**Technical Evaluation of Detailed Project Report for Proposed
Riverfront Development for River Godavari at Nashik**

CSIR- National Environmental Engineering Research Institute

September 2018

Fig1. Source: Project Goda Beautification DPR

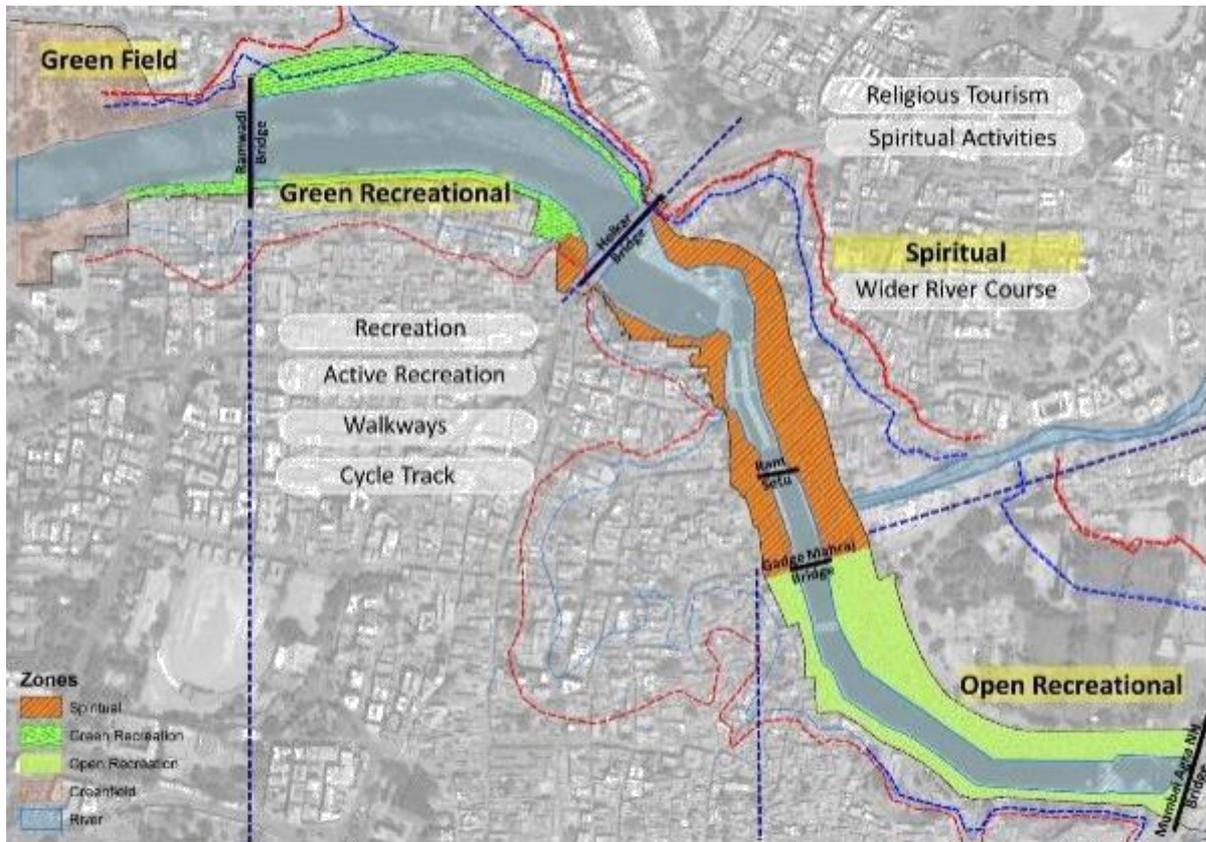
The proposed river cleaning activities include desilting and use of trash skimmer for removal of weeds and water hyacinth. However, desilting is not a permanent solution for lowering the water surface level. This is also due to the fact that siltation has not been studied with respect to its extent and problems associated with it.

Siltation: Erosion, movement and deposition of sediment and silt are natural and continuous processes regulating functions of river. Thus, long term solutions need to be adopted to reduce extent of siltation in addition to proposed desilting. Riverbank protection measures/anti erosion works help in reducing erosion and reduce silt load from the river banks. Ways to permanently reduce the silt loading in the incoming flow:

- Contour bunding
- Massive plantation in the upstream river side
